# UNITED STATES PATENT AND TRADEMARK OFFICE

APPLICATION NO.	FILING DATE	FIRST NAMED INVENTOR	ATTORNEY DOCKET NO.	CONFIRMATION NO.
10/790,100	03/02/2004	Bao Shyan Lai	MR1683-530	1207
4586	7590	06/17/2005	EXAMINER	
ROSENBERG, KLEIN & LEE 3458 ELLICOTT CENTER DRIVE-SUITE 101 ELLIOTT CITY, MD 21043			CHAMBERS, TROY	
			ART UNIT	PAPER NUMBER
			3641

<b>Office Action Summary</b>	Application No.	Applicant(s)
	10/790,100	LAI ET AL.
	Examiner Troy Chambers	Art Unit 3641

**DETAILED ACTION**

FIG. 2

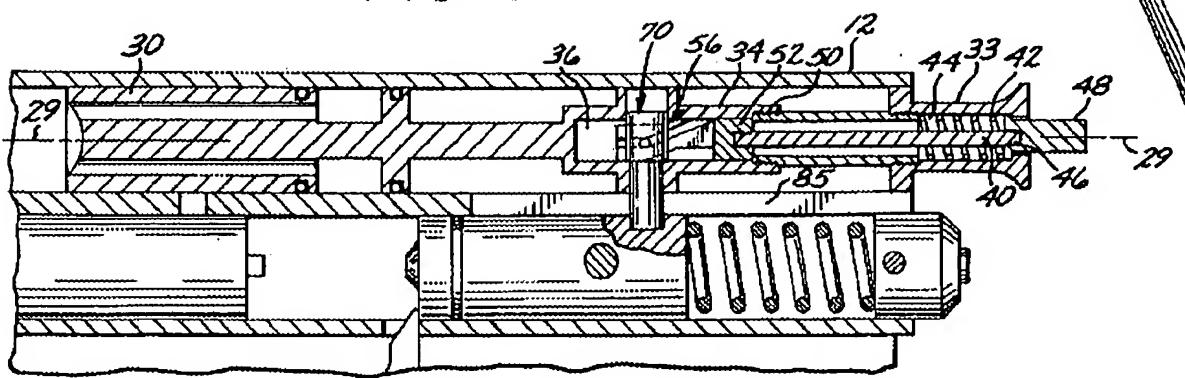
2. Claims 1, 2, 4 and 6 are rejected under 35 U.S.C. 102(b) as being anticipated by U.S. 6142136 issued to Velasco.
3. Velasco discloses a percussion device for a paintball gun 10, comprising:

a piston	18
an action	16
rear end extending out of body	35, 33, 48
an actuated rod	50
an enlarged head	48
a stick

(the stick is the rod shaped element that extends along the axis 29 from the front portion 30 to the rear portion 34)

a receiving space	36
a snapper	56, 70

FIG. 3

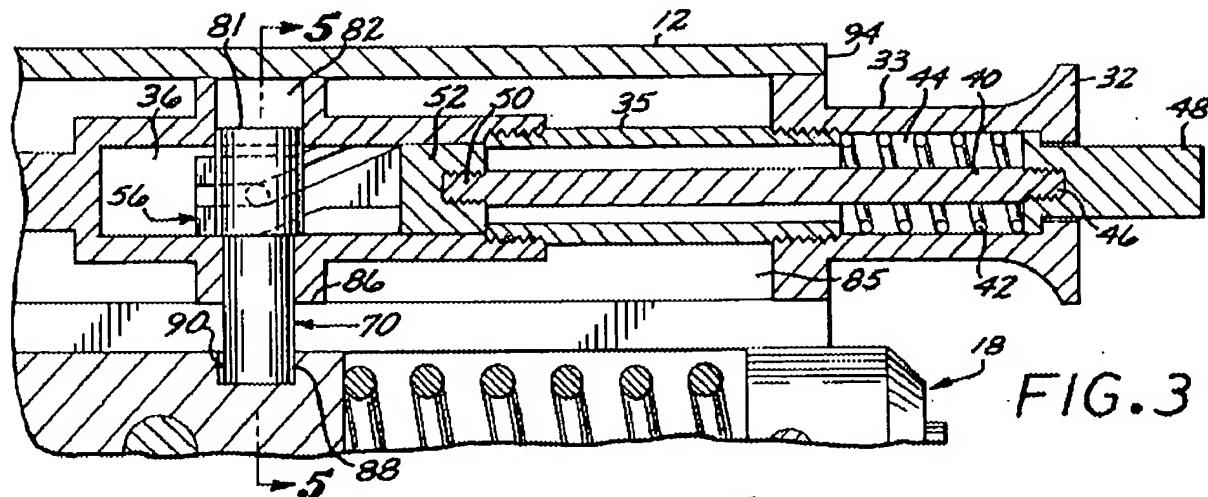
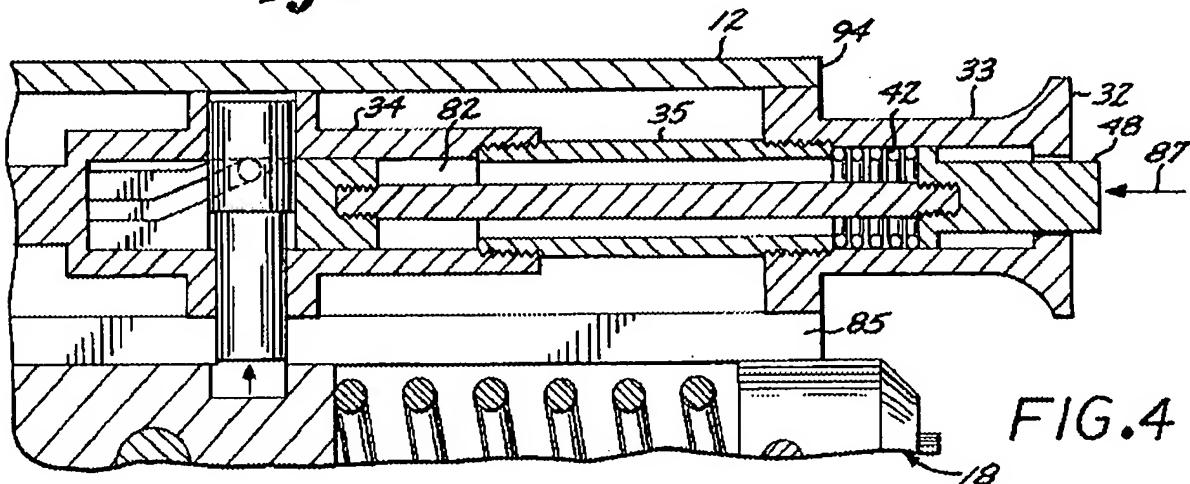
When the enlarged head 48 is pushed the actuated rod is also pushed to cam the snapper into space 36 allowing the action to be removed from the gun. (Figs. 3 and 4; col. 3, ll. 19-39).
